INSPECTION of REMOTE CONTROL TRIM SWITCHES

Merc 1500 ELPT (Serial No. 4603762-thru-4605110) and all Merc 1750 Outboards below Serial No. 4588895 must be recalled for inspection and possible replacement of the remote control Power Trim switches.

Figure 1. Spring Tension Gauge (C-91-28993)

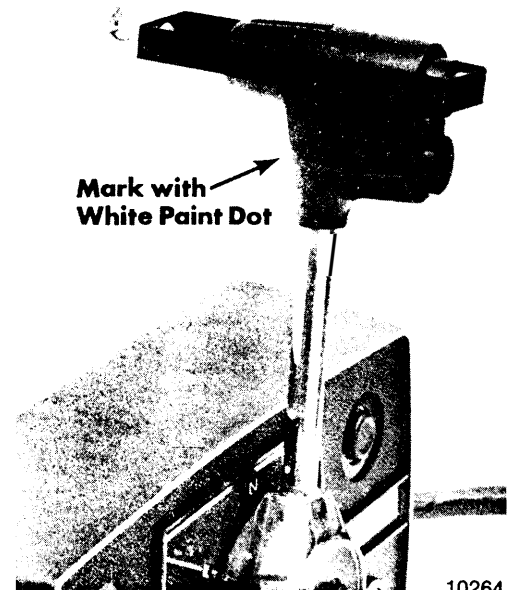
Engage trim button (both "Up" and "Down" buttons), then check button release. Button must release at a minimum of 13 oz. (.94kg-cm). Any switch that releases under 13 oz. must be replaced. Place a small white paint dot on handle for future identification, as shown in Figure 1.
